OUT15/30074

**Roberts Road Quarry Modification 2 (DA 267-11-99 Mod 2)  
Response to exhibition of Environmental Impact Statement**

### Roberts Road Quarry Modification 2 (DA 267-11-99 Mod 2) Response to exhibition of EIS Detailed comments - DPI Water

**Figure 2 AGT report hydrograph**

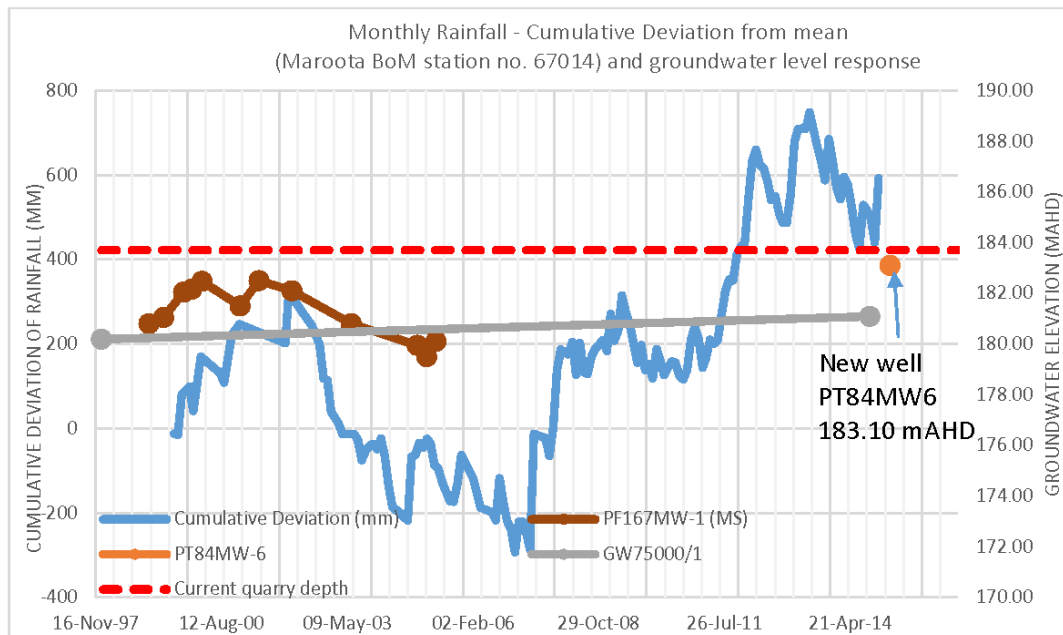
A hydrograph provided in the AGT report (p.16) illustrates the data considered in the assessment (Figure 2).

- 12 measurements of groundwater level from an off-site bore (PF167MW-1, located 750m to the southwest) all recorded prior to May 2005.
- 2 measurements of groundwater level from a NSW Government monitoring bore (GW075000/1, located 1,300m to the southwest) in around November 1997 and around April 2014.
- 1 measurement from the single on-site monitoring bore (PT84MW-6, installed as a replacement for PT84MW-3) on 3 March 2015.

That hydrograph highlights the encroachment of extraction on the water table, as the identified current quarry depth is considerably less than 2m above the groundwater level measured in March. This is illustrated by a cross section in the AGT report (p.18), which is reproduced below (Figure 3).

**Figure 3 AGT report cross section**

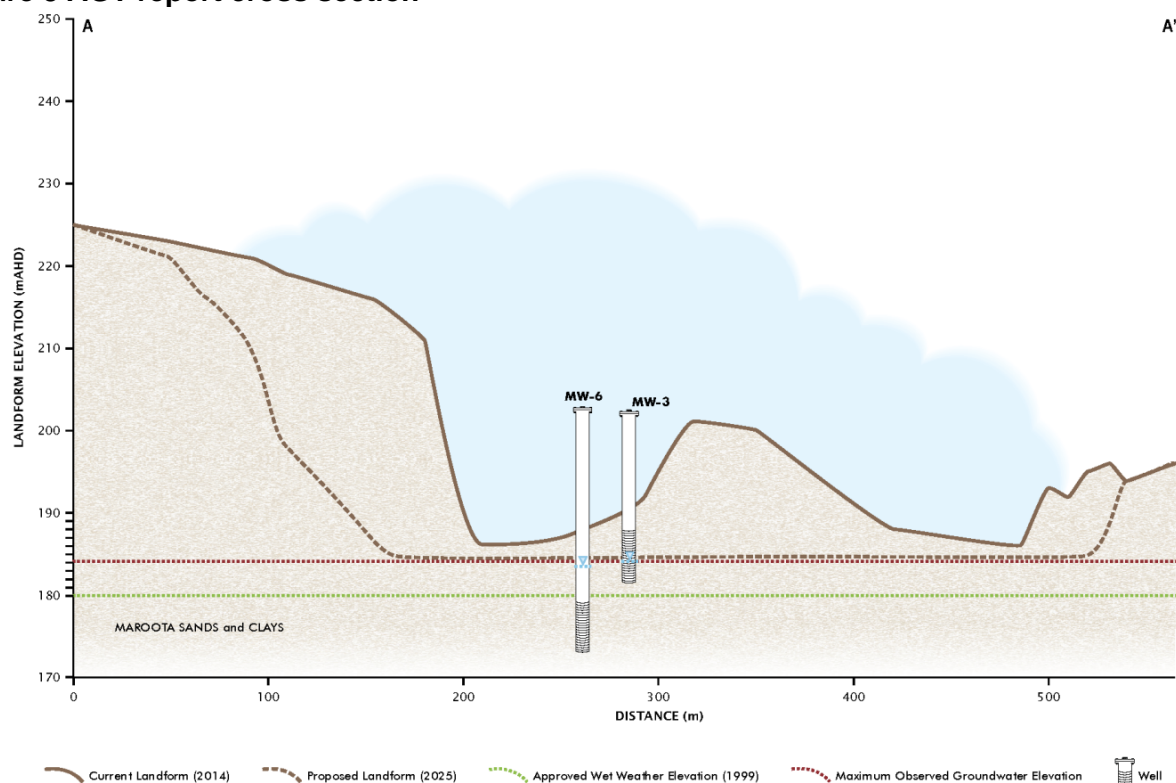
- It is of concern that current excavation cells with base elevations of less than 186.08m AHD are less than 2m from the water table. There is no documentation about filling over excavated areas with Natural Excavated Materials (NEM) or Virgin Excavated Natural Materials (VENM)—in accordance with EPA Guidelines—to achieve the elevation requirement.

- Restriction on the absolute depth of extraction to 186.08m AHD for the entire period of quarry operation (regardless of any future extension to the consent) unless higher wet weather groundwater levels become apparent.
